Access Compliance Report

Public Rights-of-Way

(Curb Ramps)

Intersection ID: 11882	Main Street: N_PINE_ST	Cross Street: W_5TH_ST	Location: S
ADA ID: E924475C39CF	Ramp Type: Directional1	Initial Pass/Fail: Pass	Overall Compliance: No
Severity Score: 5.25			
Codes/Mitigation Info/Possible Solution		Field Measurements/Component Compliance

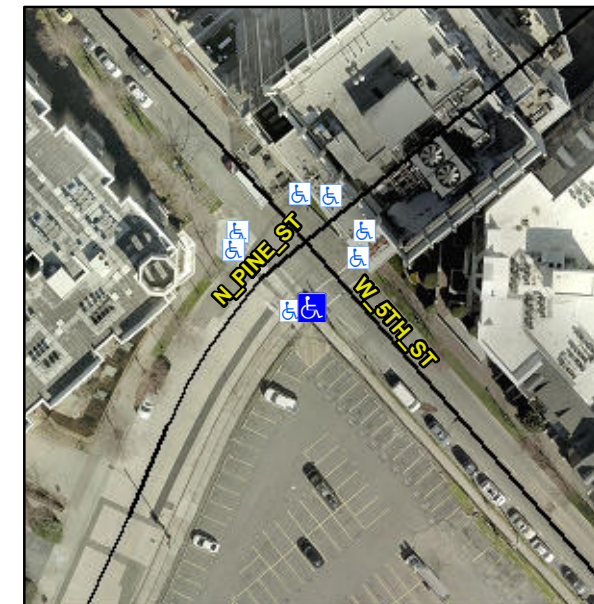
R304.5.3, R304.2.3

Compliance	Description	Data	Compliance	Description	Data
N/A	Ramp Length (in)	91.0	Yes	Grade Break?	Yes
Yes	Ramp Width (in)	51.0	No	Grade Break Slope (%)	7.9
Yes	Ramp Slope (%)	6.1	Yes	Grade Break XSlope (%)	0.3
No	Ramp XSlope (%)	4.6			
N/A	Flare Type LT	N/A	No	Flare Type RT	N/A
N/A	Flare Slope LT (%)	N/A	N/A	Flare Slope RT (%)	N/A
N/A	Flare Traversable LT?	N/A	N/A	Flare Traversable RT?	No
Yes	Landing Length (in)	60.0	Yes	DWS Provided?	Yes
Yes	Landing Width (in)	53.0	Yes	DWS Contrast?	Yes
Yes	Landing Slope (%)	0.9	Yes	DWS Length (in)	24.0
No	Landing X Slope (%)	2.8	Yes	DWS Full Width?	Yes
N/A	Landing Curb? (Y/N)	N/A	Yes	DWS Offset LT (in)	11.0
N/A	Shared Landing?	Yes	Yes	DWS Offset RT (in)	2.0
Yes	Gutter Ponding?	No	Yes	Gutter Slope (%)	2.6
Yes	Gutter Lip Ht (in)	0.0	Yes	Gutter X Slope (%)	0.4
N/A	Painted X Walk1?	Yes		Road Slope (%)	5.0
	X Walk 1 Direction	To NE		Road X Slope (%)	0.8
	X Walk 1 Width (in)	110.0		Clear Space?	Yes

Remove & Replace Entire Ramp.
